[Final environmental impact statement: Flambeau Mining Co., copper mine, Ladysmith, Wisconsin]. 1990

Madison, Wisconsin: Department of Natural Resources, Bureau of Environmental Analysis and Review, 1990

ENVIRONMENTAL IMPACT STATEMENT PROCESS

Figure 1-1
Project Location in Rusk County

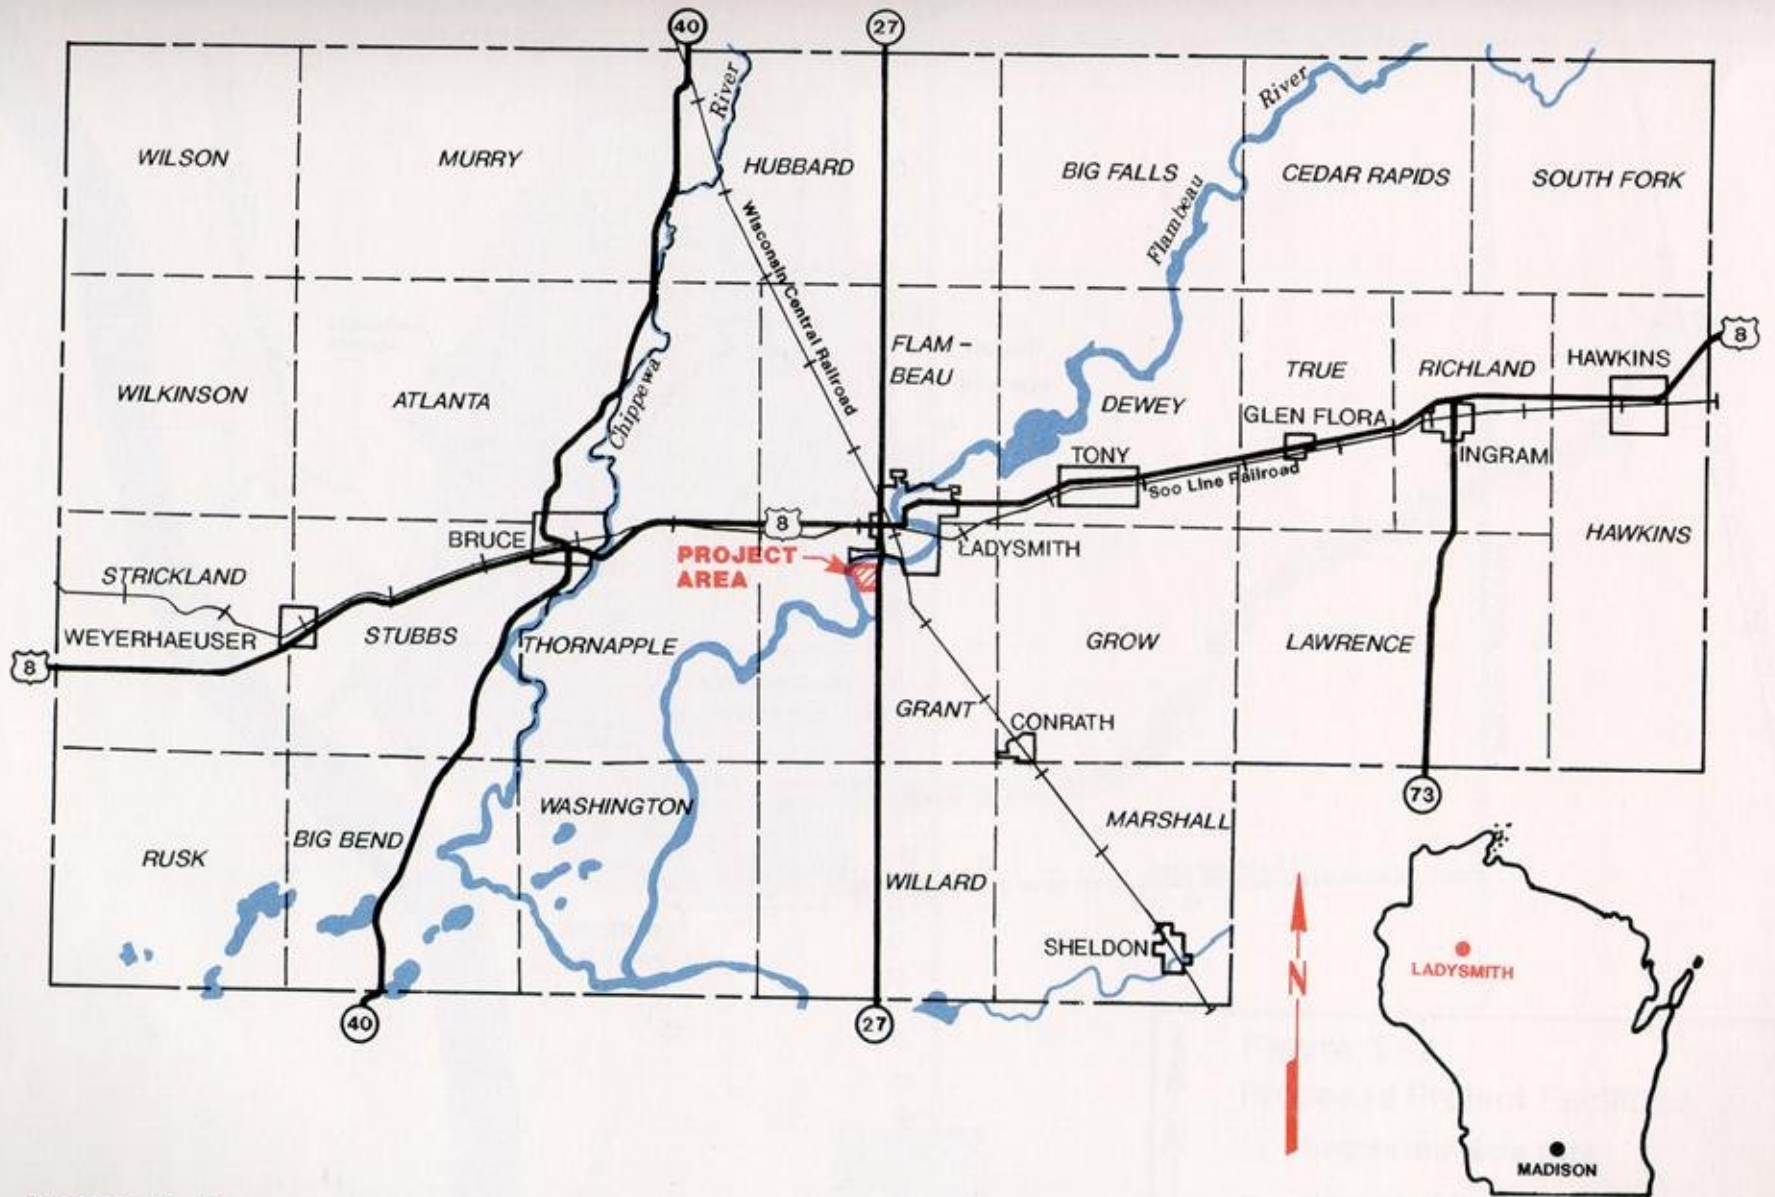
19. Fig 1-1. Add a scale. [TE]
20. Fig 1-2. Clearly delineate "project area," "mine site", and the area subject to the proposed mining permit on this illustration. [TE]

Figure 1-4 Open Pit Cross Sections

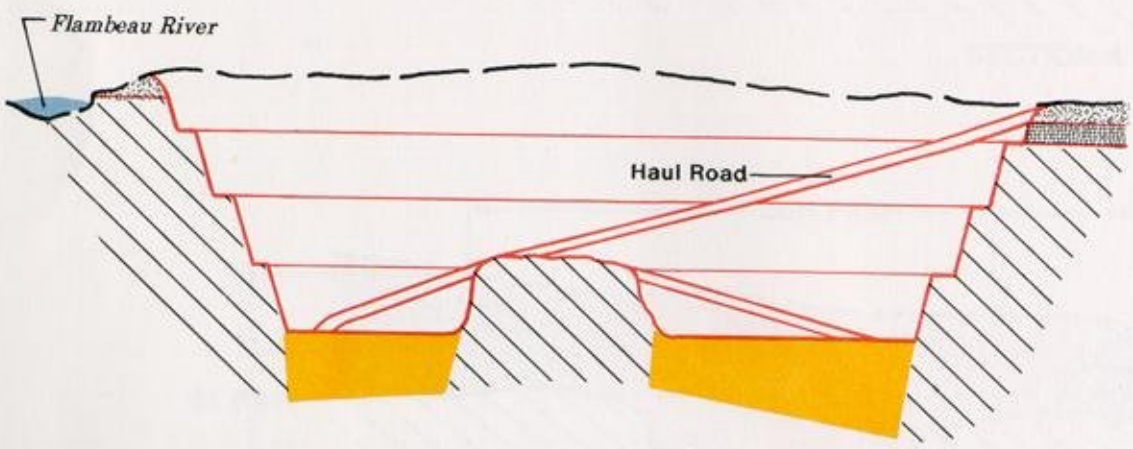
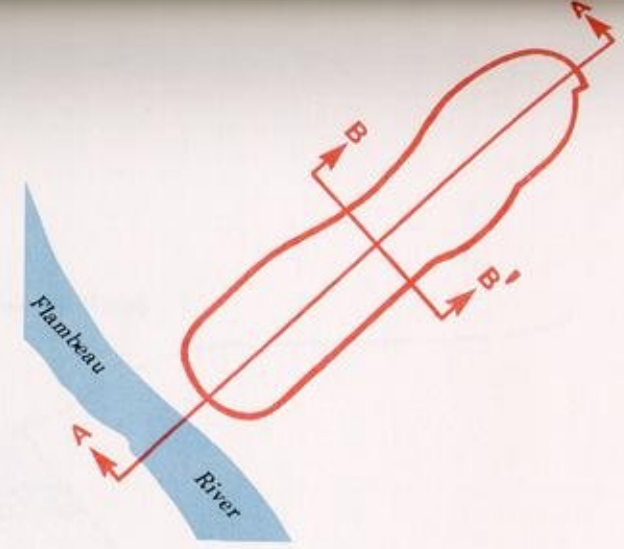
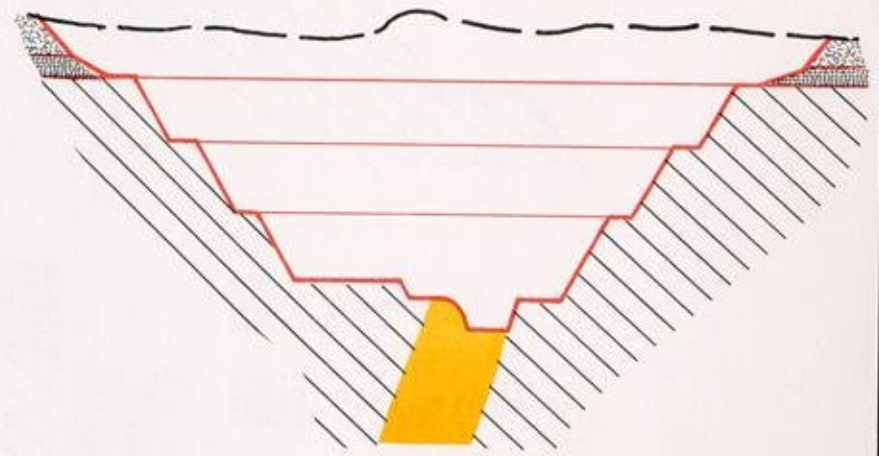
22. Figure 1-4. Use of term "bedrock" appears to exclude the sandstone, but the Cambrian-age sandstone is part of the area's bedrock. The hachure-symbol unit designated "bedrock" should be redesignated as "Precambrian crystalline rock" or "crystalline rock." See Figure 1-5. [MW, TE]

Response 36 - Figure 1-4 was modified to address this concern.

Figure 2-5
Private Wells Sampled to Establish Baseline Conditions

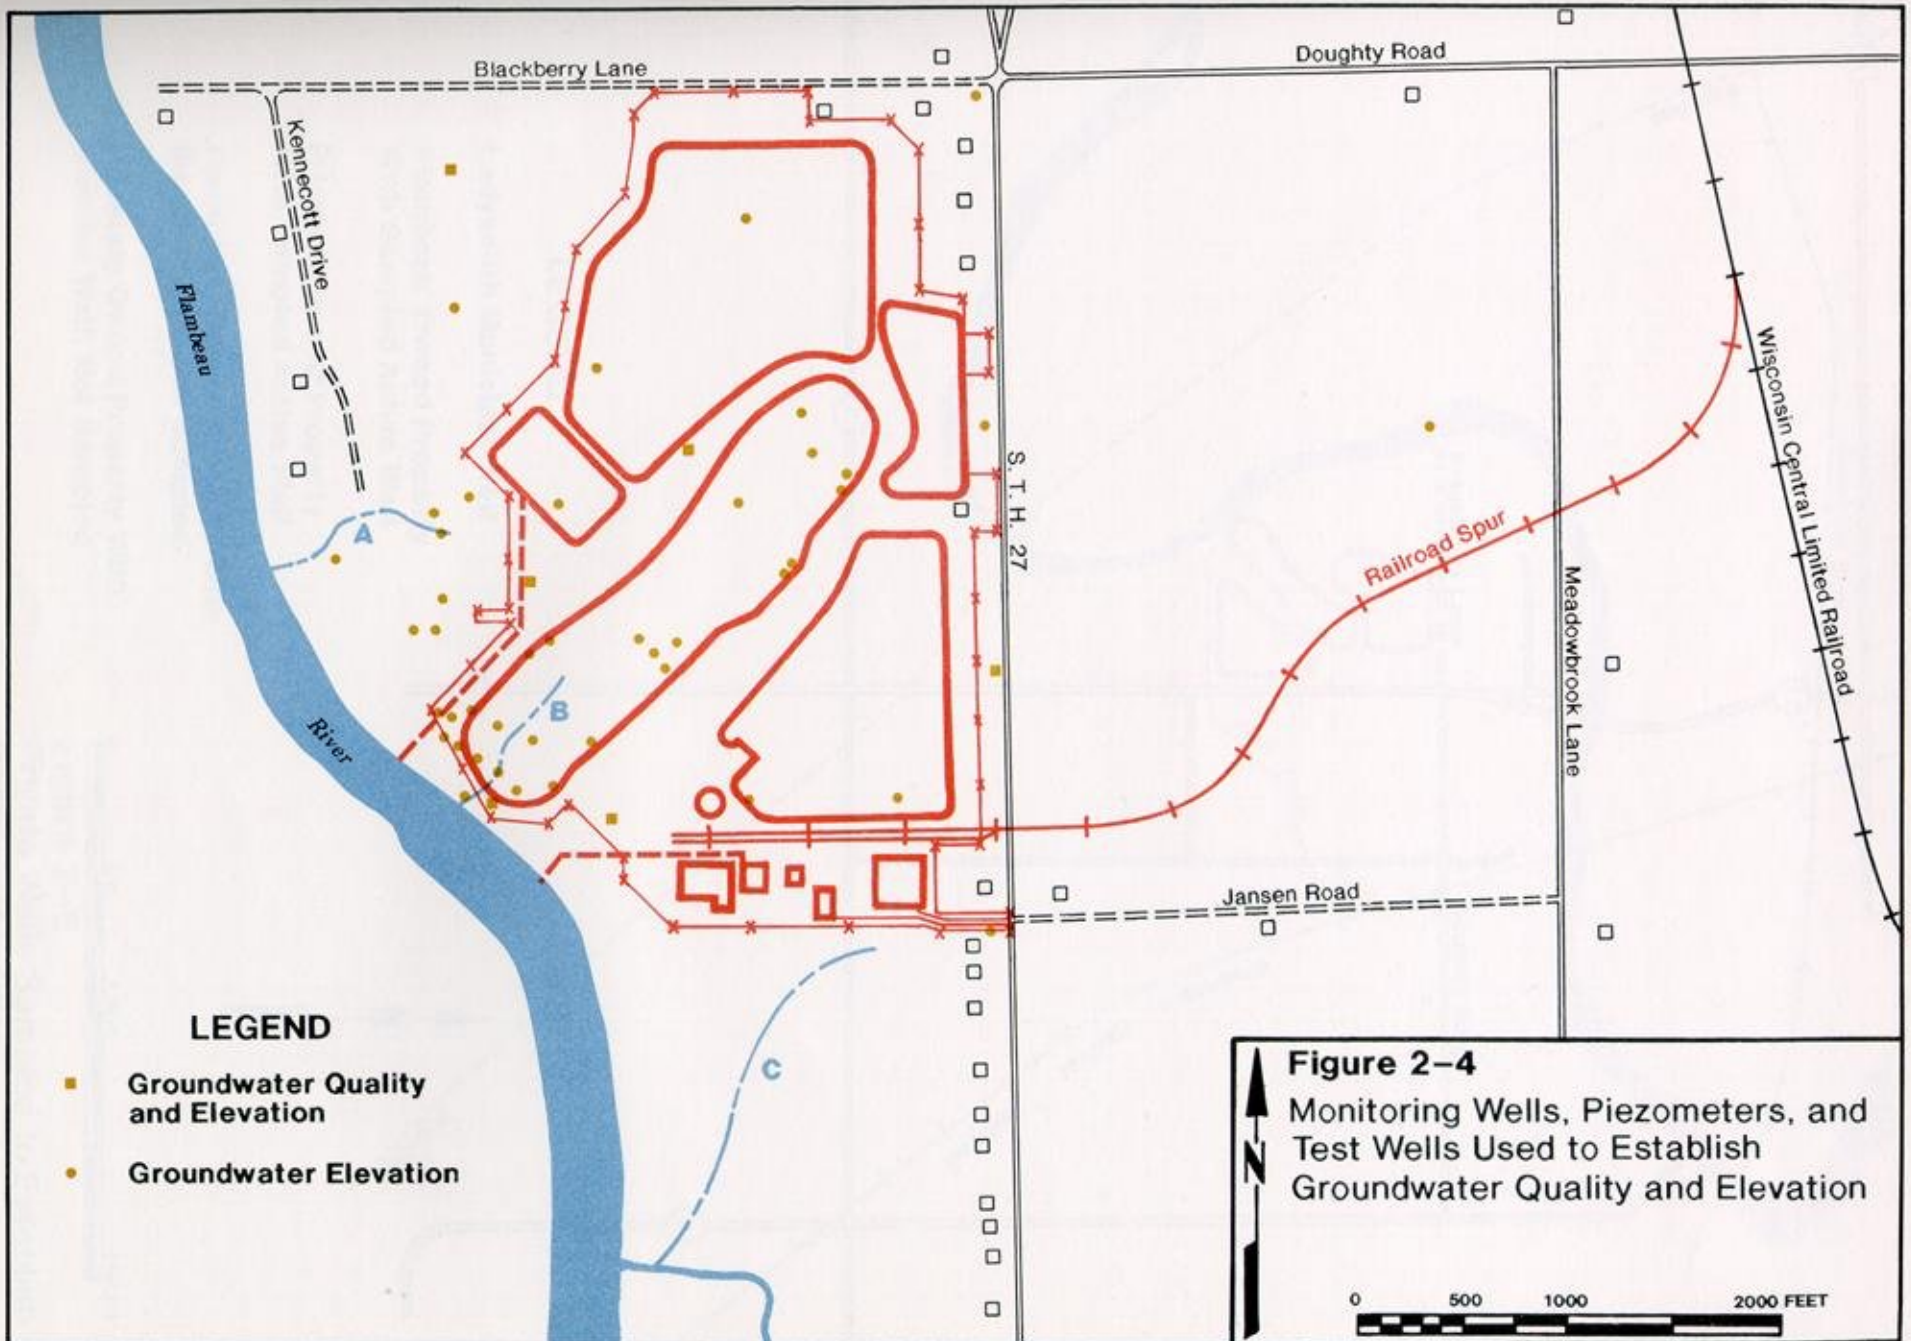
54. Figure 2-5. Figure shows privately owned wells on land that Figure 1-3 indicates is Kennecott property. Which is correct? [TE] (68)
55. Page 24 & 25 (Groundwater Flow).

Response 68 - Figure 2-5 of the DEIS was correct.

Figure 2-9
Intermittent Streams and Wetlands

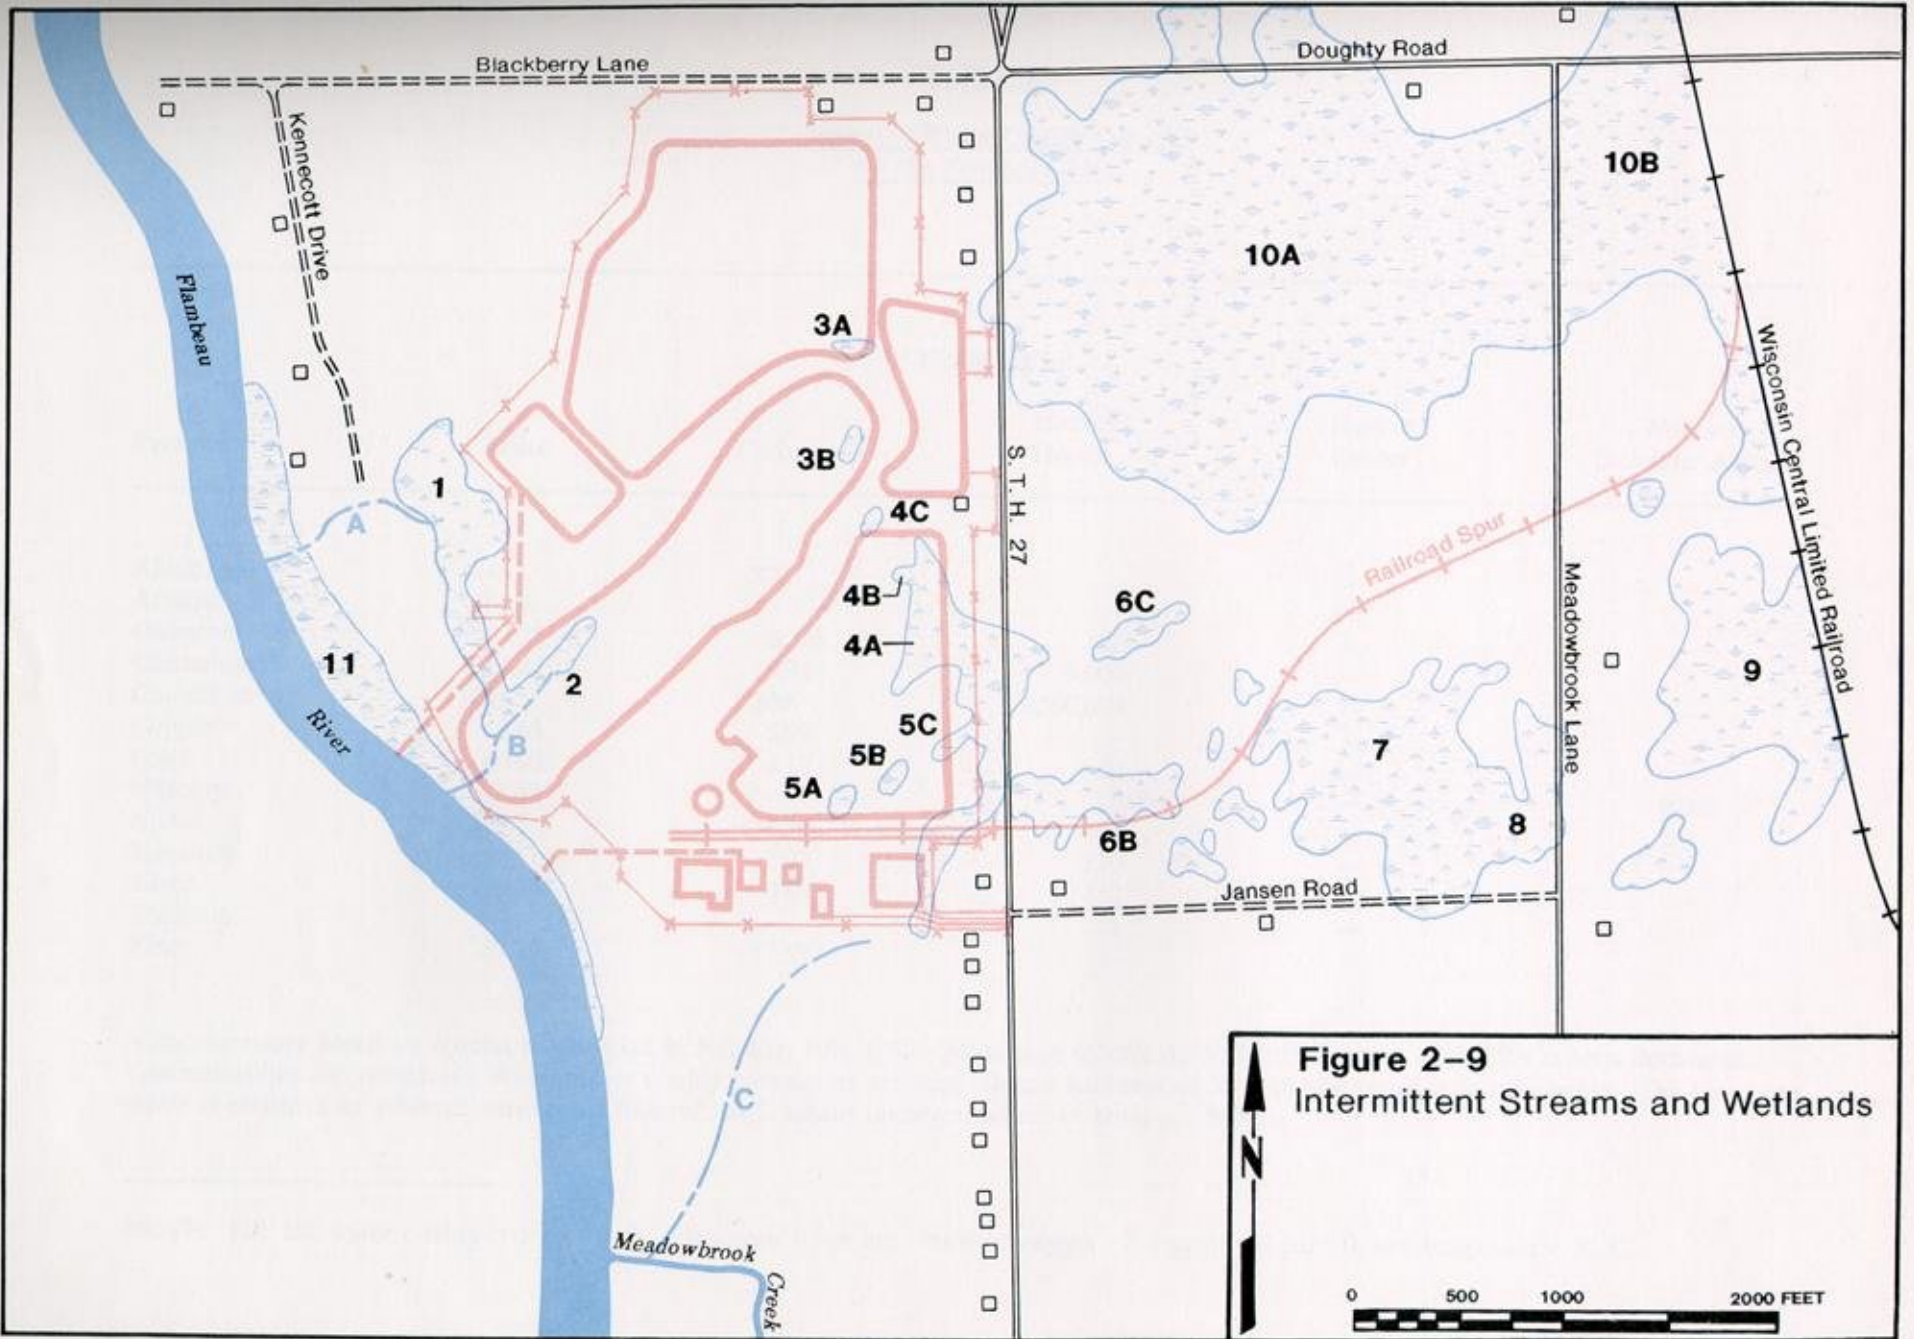
63. Figure 2-9. Add numbers identifying individual wetlands and draw in boundaries delineating these more clearly. [TE]
